## Product Change Notice (PCN)

**Subject:** Transfer of back-end production for general-purpose linear IC products (MSOP package products)

**Publication Date:** 1/19/2024

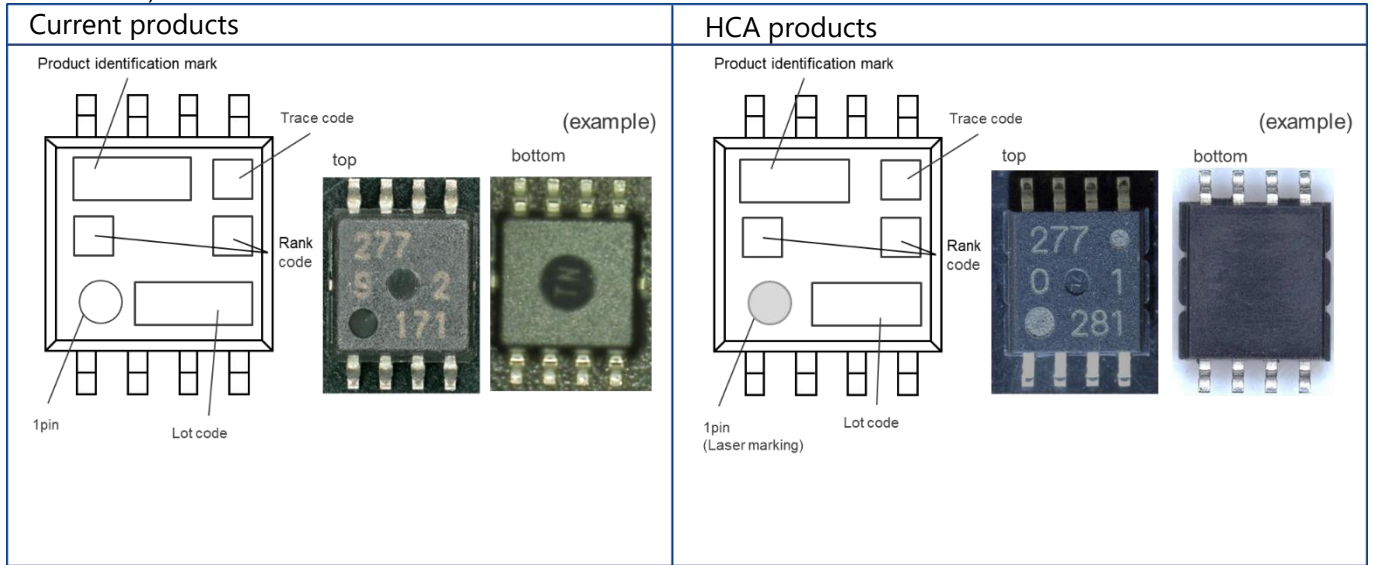
The size of the tape packaging box is different as follows.

Current products (L×W×H)	HCA products (L×W×H)
368×347×54 (mm)	361×341×58 (mm)

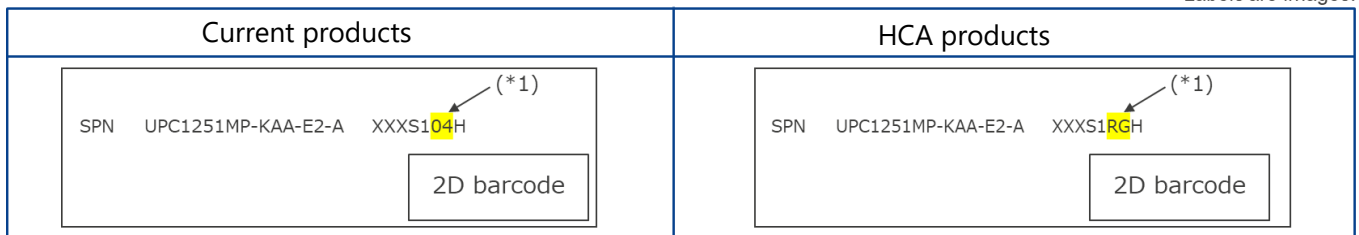
Production sites can be identified by labels (reels, packaging boxes).

Examples of products beginning with UPC  
 (\*1) characters: 04 → RG

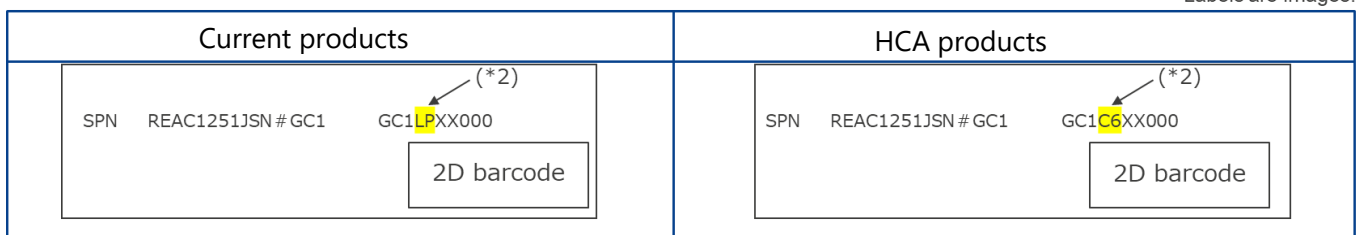
Examples of products beginning with REAx  
 (\*2) characters: LP → C6
